Common Structural Rules for Bulk Carriers and Oil Tankers

Technical Background for Urgent Rule Change Notice 1 to 01 JAN 2014 version

Pt 1, Ch 9, Sec 4, Table 4, ID31 and ID32

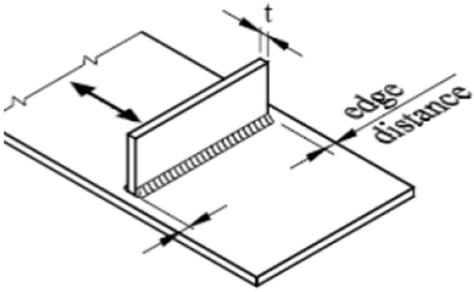
In order to resolve the gap between CSR-BC and CSR-H, the stress concentration factor for the connection type of ID31 and ID32 are modified.

The 1.13 factor for K_a comes from the picture below also taken from CN30.7, i.e. it is simply a transverse attachment to the longitudinally loaded plate. This is also given in IIW. It is dependent on the attachment thickness, but the frames are in generally less than 25mm, so 1.13 should be OK to consider in CSR.

The 1.2 factor used in detail 31 and 32 includes some additional uncertainty related to the design of the collar/lug and bending effects.

K-factors for stiffeners welded to a plate	
<i>Geometry</i>	<i>K-factor</i>
	$K_{ge} = 1.13$ if $t \leq 25$ mm $K_{ge} = 1.27$ if $t > 25$ mm
